SECTION 00911 - ADDENDUM 2

- A. Project Name: South Main Corridor Improvement Project (Phase II)
- B. Engineer: SK Design Group, Inc.
- C. Engineer's Project Number: 16-108.
- D. Date of Addendum: August 3, 2023

South Main Corridor Improvement Project (Phase II)

CONTROLLER SCHEDULES

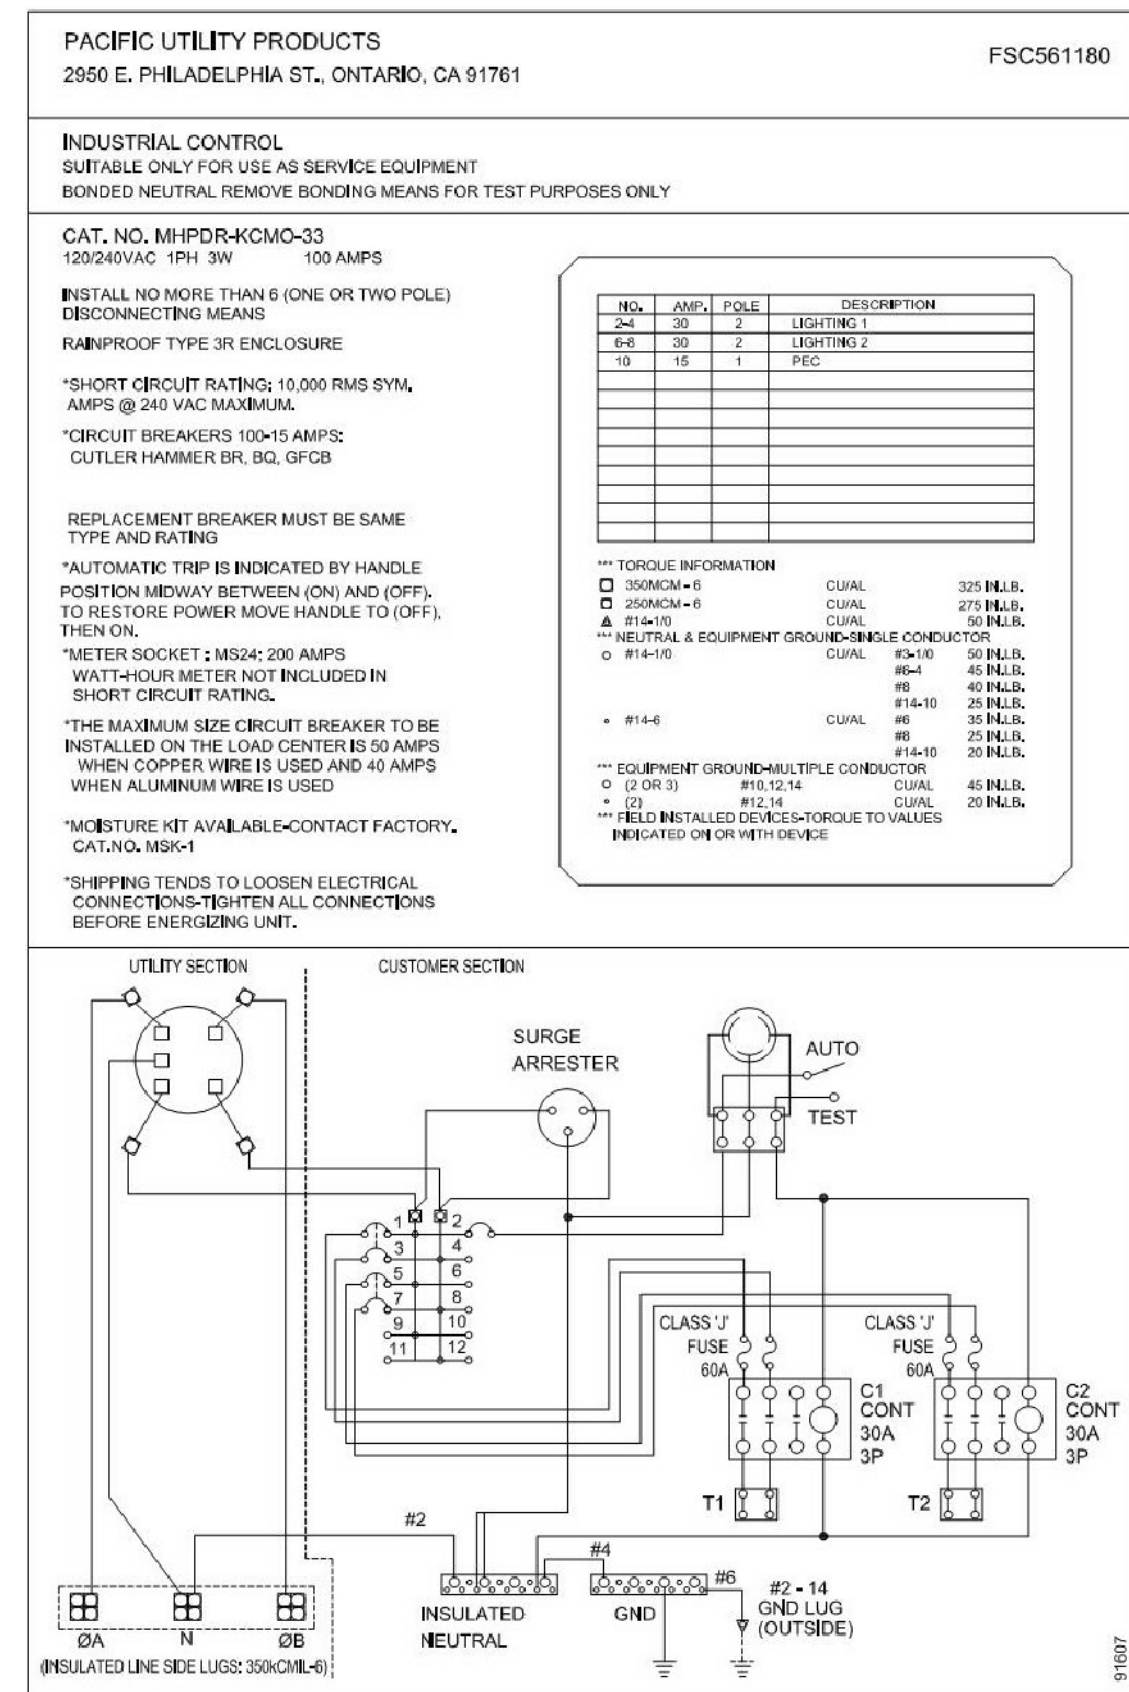
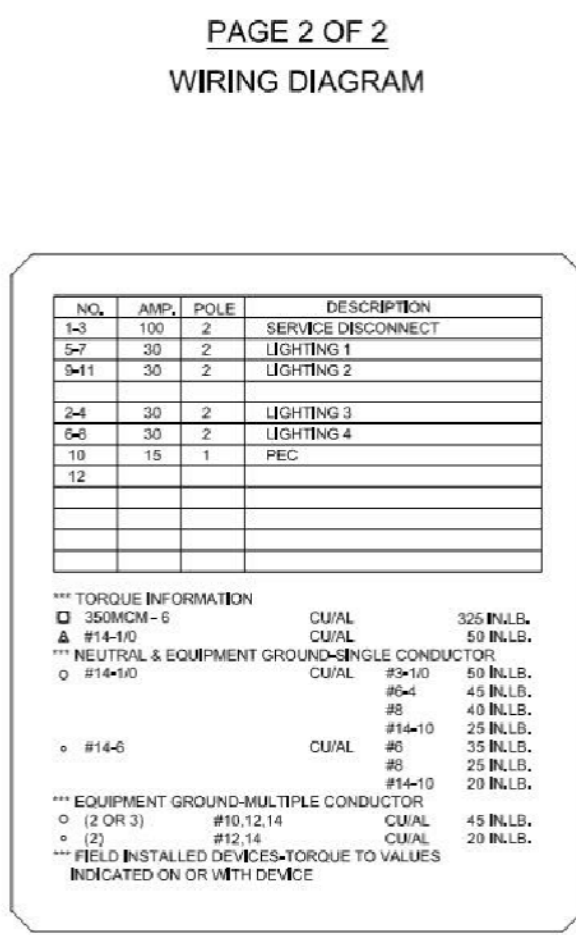
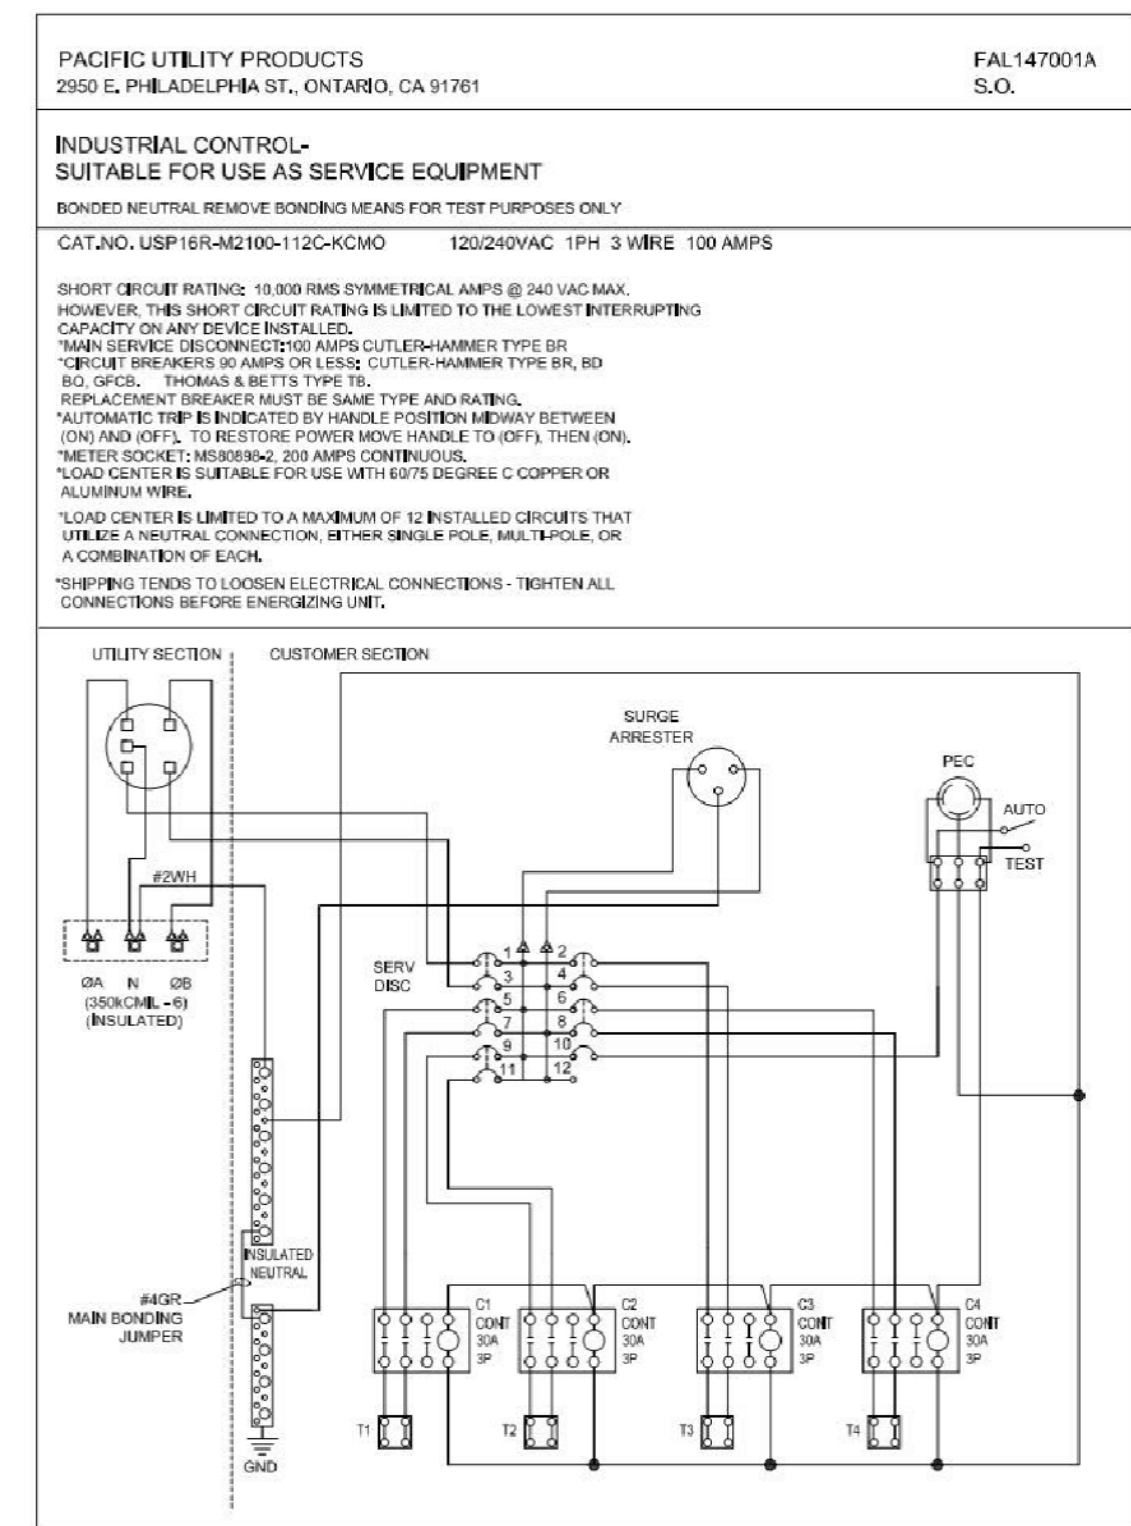
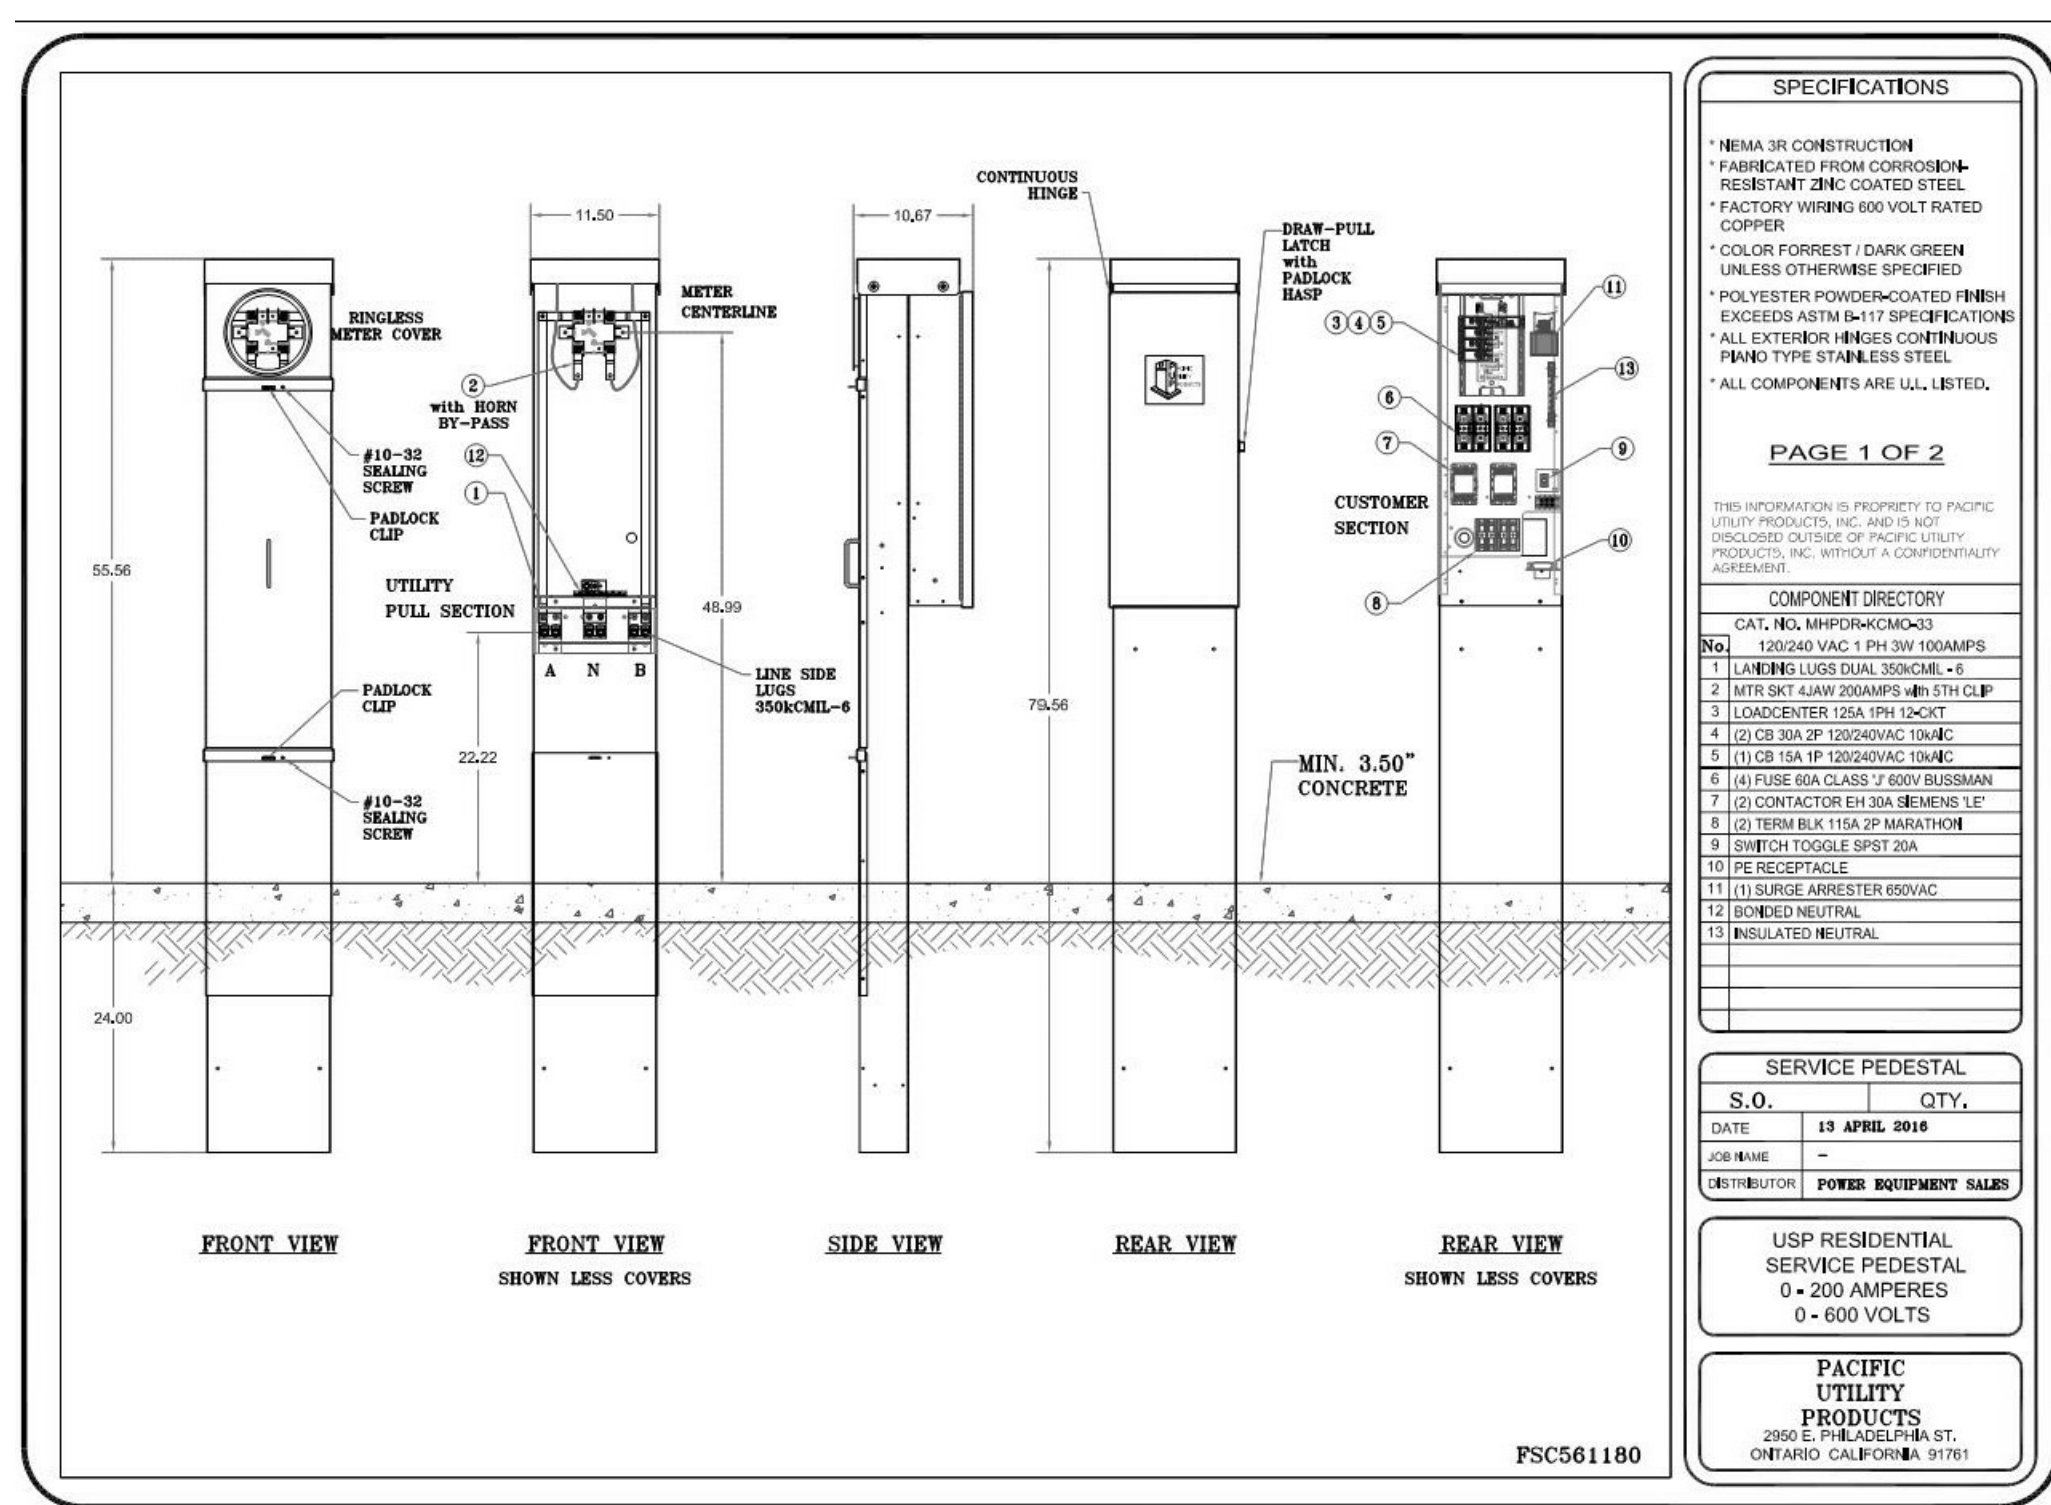
- G. Question: On sheet SE303 under the controller schedule it shows on controller F that circuit 3 is used for signage. On the drawings there is no indication of signage lighting on controller F. Please clarify if signage lighting is to be installed.

Response: Controller F schedule is revised to include "Streetlighting/Signage." See attached revised sheet SE303. Refer to Note 6 on SE204 for location where signage is located.
